# Interim Reclamation and Stormwater Inspection

Operator: EXTRACTION OIL & GAS LLC- #10459

Location ID: 439079

Inspection Photos  
Location Name: Kennedy /18-D Pad  
Location ID: 439079

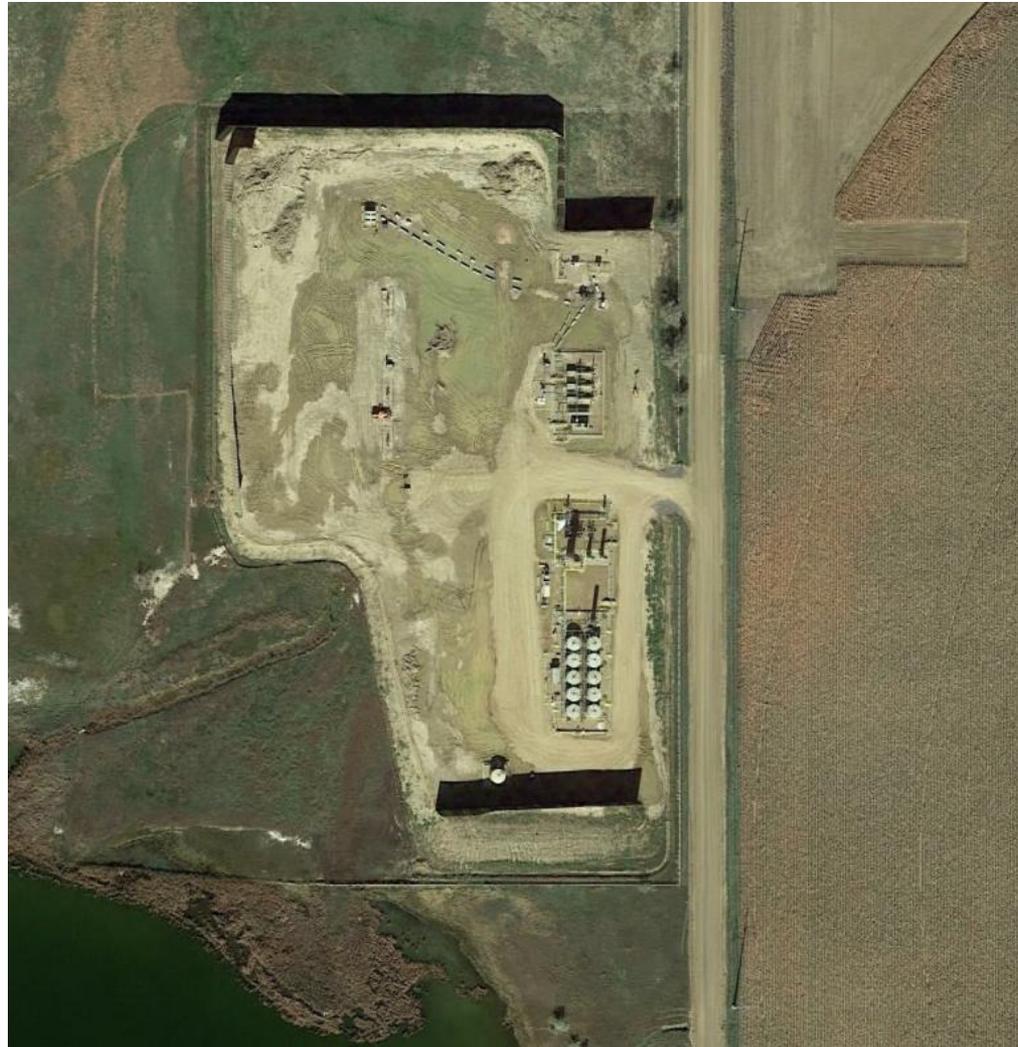
Google Earth aerial photo taken October 14, 2017 of the Kennedy Pad, totaling 8.03 acres of construction disturbance. This is the current state of total disturbance observed on February 14, 2018. Operator has failed to perform interim reclamation by the required date.
